**DOCUMENT 00 90 00  
ADDENDUM**

**ADDENDUM NO. [6]                      Date: May 22, 2018**

**RE:                      WESTERN TECHNICAL COLLEGE  
                             INDOOR SHOOTING RANGE  
                             11177 COUNTY RD A  
                             SPARTA, WI 54656**

**FROM:                HSR Associates, Inc  
                             100 Milwaukee Street  
                             La Crosse, WI 54603  
                             (608) 784-1830**

**M100R**

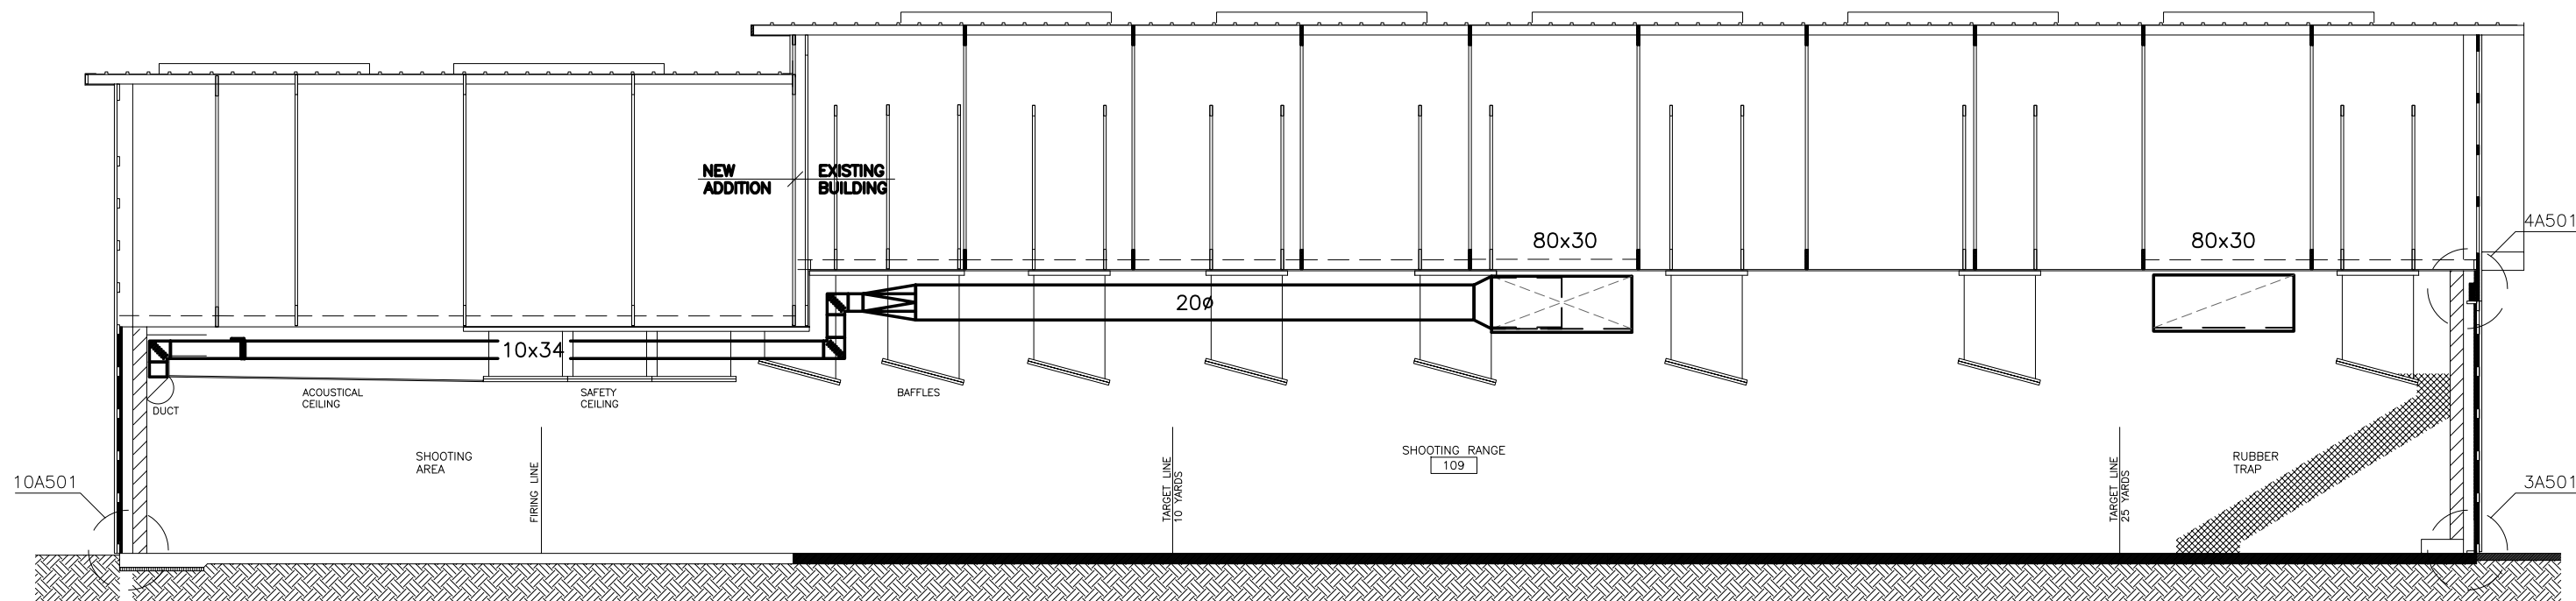
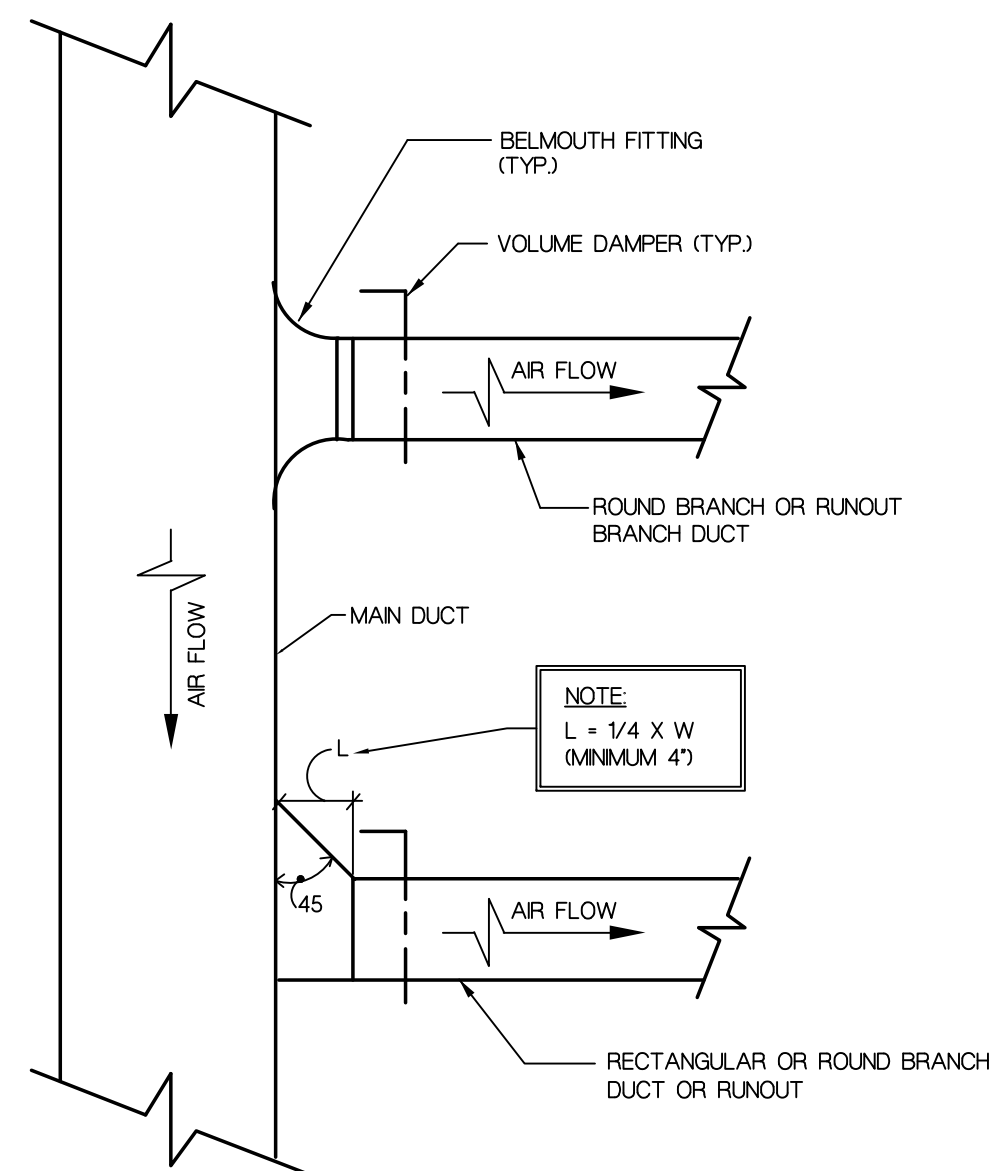
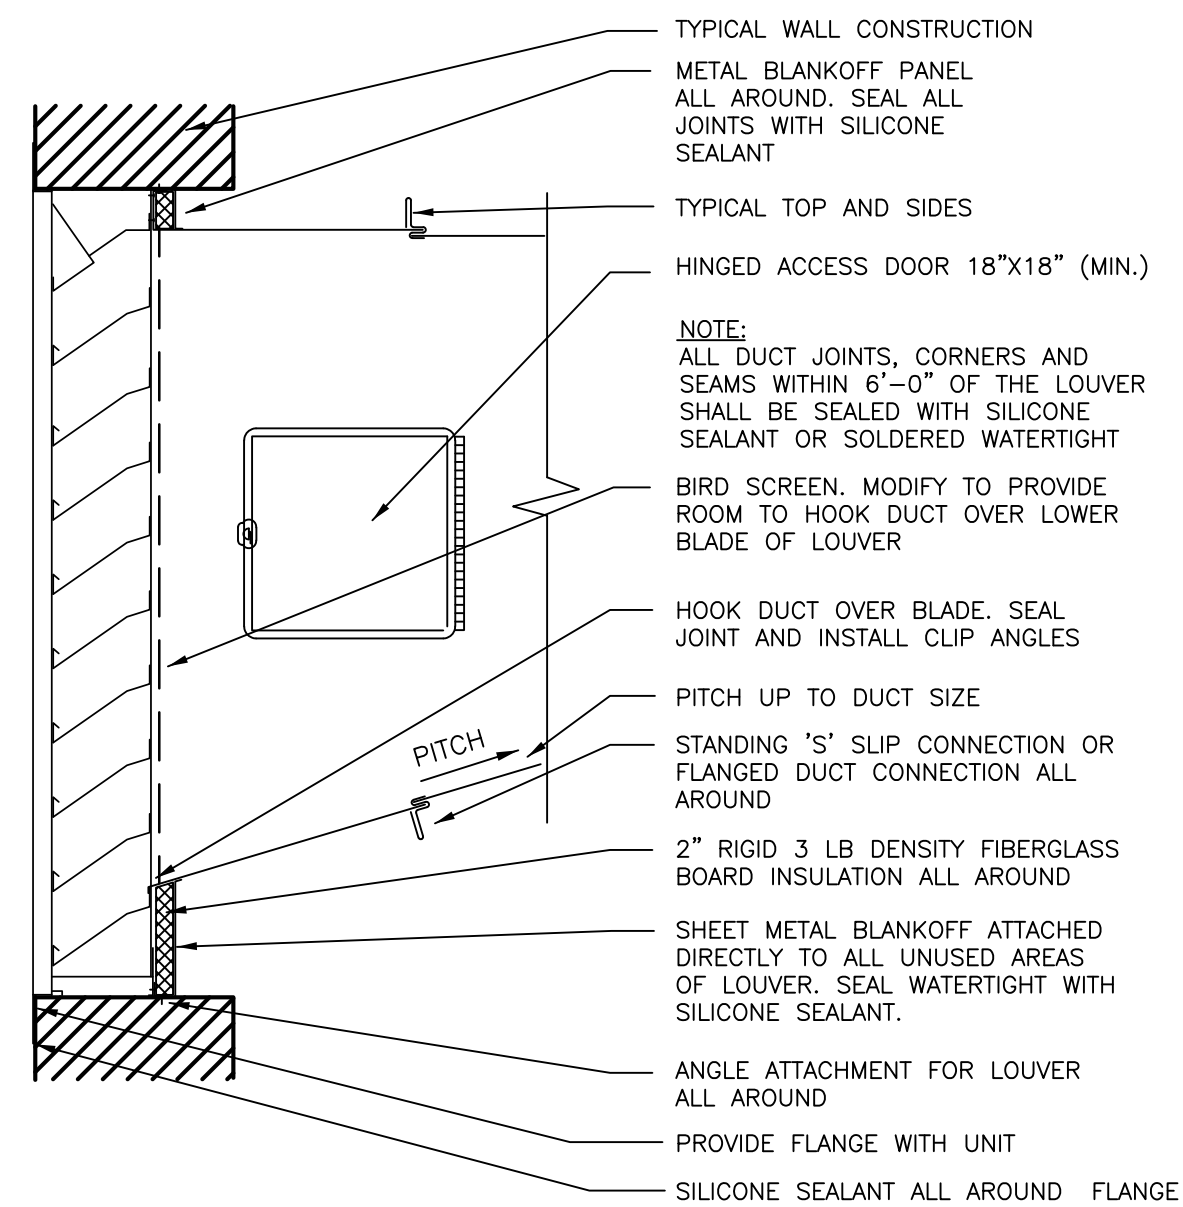
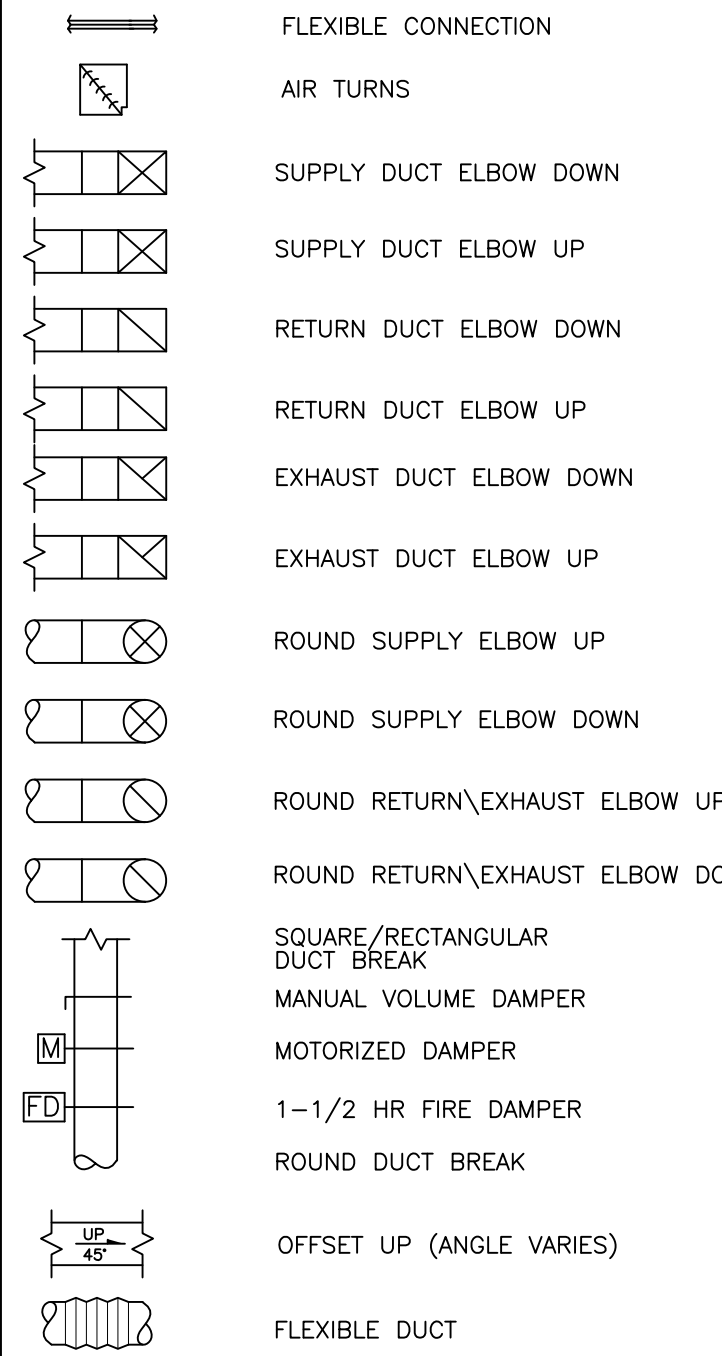
1. Sheet M100R HVAC DUCTWORK PLAN, SECTIONS AND DETAILS 24 x 36 attached hereto
  - a. Revisions clouded on Drawing.
2. Sheet M101 HVAC PIPING PLAN
  - a. 1M101 HVAC PIPING PLAN – Heating pumps shall be HWP-1 AND HWP-2 in lieu of P-1 and P-2.
3. Sheet M600R1 HVAC SCHEDULES 24 x 36 attached hereto
  - a. Revisions clouded on Drawing.
